Work Order ID 92597

Item Name: 205 Skidtube bent detail

DRAWING NO. D2580	TITLE 205 SKIDTUBE ASSEMBLY	REV. E	DART AEROSPACE LTD ENGINEERING ORDER	D.E.O. NO. D2580-E-1	SHEET NO. SHEET 1 OF 1	SCALE NTS
DRAWN <i>UP</i>	CHECKED <i>ASS</i>	MFG. APPR. <i>EC</i>	APPROVED <i>#</i>	DE APPR. <i>#</i>		
DATE 11.12.13	DATE <i>11.12.13</i>	DATE <i>11.12.13</i>	DATE <i>11.12.13</i>	DATE <i>11.12.13</i>

CHANGE ALL C'BORED WELDED CROSSBOLT SPACERS TO SWAGED SPACERS

SECTION B-B, F-F, I-I
NOT TO SCALE

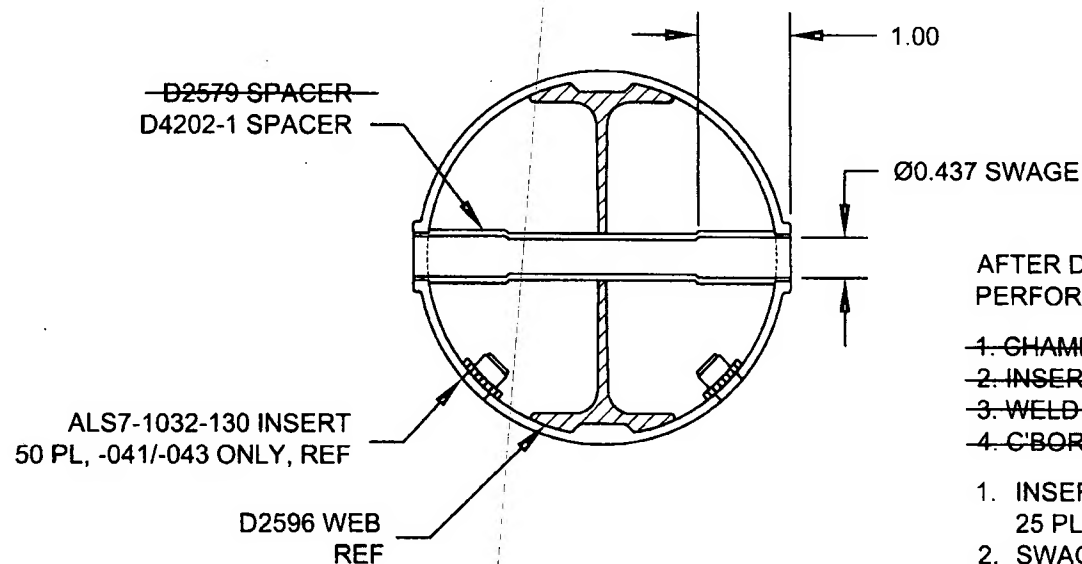
SECTION B-B, SECTION F-F, & SECTION I-I ARE AMENDED AS FOLLOWS
FOR ALL HOLES THAT WERE ORIGINALLY C'BORED:

*** FOR -045 SKIDTUBE ONLY:**

WELD 4X D2579 SPACERS PER DWG
IN LOCATIONS MARKED "NO C'BORE".
REF SHEET 4 OF DWG.

1. INSERT D4202-1 SPACER, 20 PL (-041) OR 20 PL (-045) OR 25 PL (-047)
2. SWAGE TO Ø0.437 X 1.00 DEEP PER QSI 002
3. TRIM / GRIND FLUSH PER QSI 002
